CAPRICORN MUNICIPAL DEVELOPMENT GUIDELINES

2024 MEETING 7 MINUTES

Venue: Teams
Date and Time: 29th August 2024 at 11:00 am

D14 Floodways

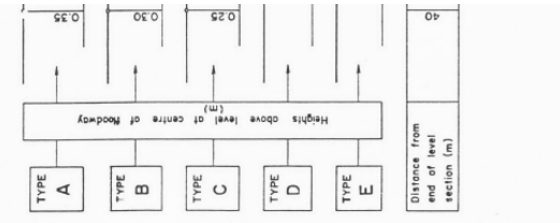
GRC comment in relation to rock sizing for bed level crossing has been reviewed and a revised formula in accordance with QUDM will be included as the exact reference/ justification for the current formula proposed in unknown.

- 1. I have some comments over the “Development Approval” parts. A floodway should be defined as an Operational Works under Planning Act 2016. If a floodway needs to be constructed by a developer, it is very likely that it is triggered because of a subdivision. In our planning scheme, any Operational Works associated with a subdivision (ROL application) is code assessable, i.e. Operational Works permit is required. Even it is not associated with ROL, as a floodway is very likely to be handed over to Council as Council’s asset, I expect Operational Works Permit is a must as this will allow Council officers to inspect, review and record the as-constructed data, having defects period and etc.

- 2. I understand that D14.01.05 has mentioned MUTCD. But I thought maybe better to have a bit more specified clauses related to the traffic signs related to a floodway? Such as “road subject to flooding” and the scale showing the flood depth.

I don’t think that there will be any scenario that does not require either operational works approval or a works in road permit so Council should have opportunity for review and comment. Floodway signage has varying requirements depending on road environment. Section D14.10 includes some signage requirements at the floodway.

STANDARD FLOODWAYS

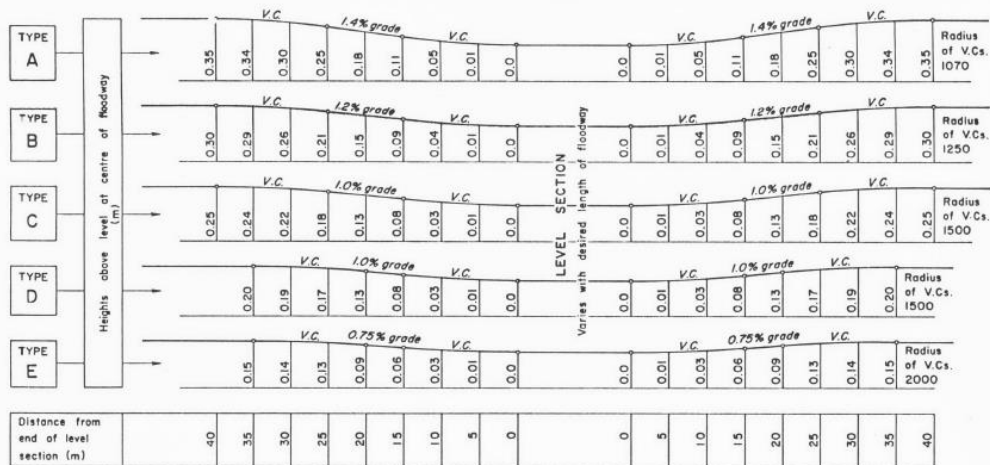
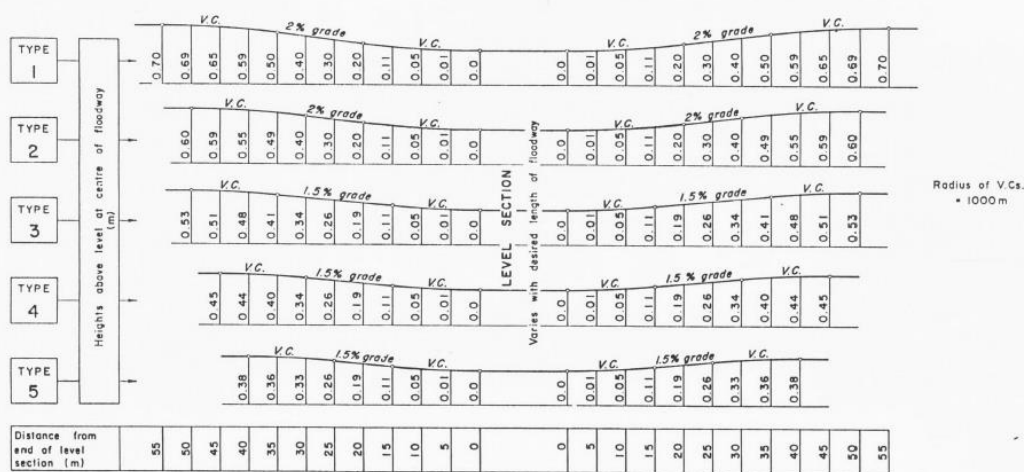
- Allen Chen (LSC) raised that the draft D14 document identified that the works do not need to be approved.
 - D14.22.01 change reference from SPA to the Act.
 - Agreed signage on standard drawings is OK.
 - Agreed to add a clause noting that for specific approval requirements to contact the LGA.
- Brendan Fuller (GRC) raised the need to include set longitudinal sections as part of the doc. Grant Vaughan (RRC) suggested that this info might not be useful in modern practice. Jarvis Black (MRC) requested a copy of the long sections for review to determine if useful for MRC's rural roads. Richard Bywater (MCE) to provide.
- Brendan Fuller (GRC) queried the rock sizing formula. Richard (MCE) advised that it is still in progress to ensure there's a basis for the proposed equation/chart. Brendan recommended using the information from Austroads.

- MCE to provide the longitudinal sections to MRC for reference and make the changes noted above.
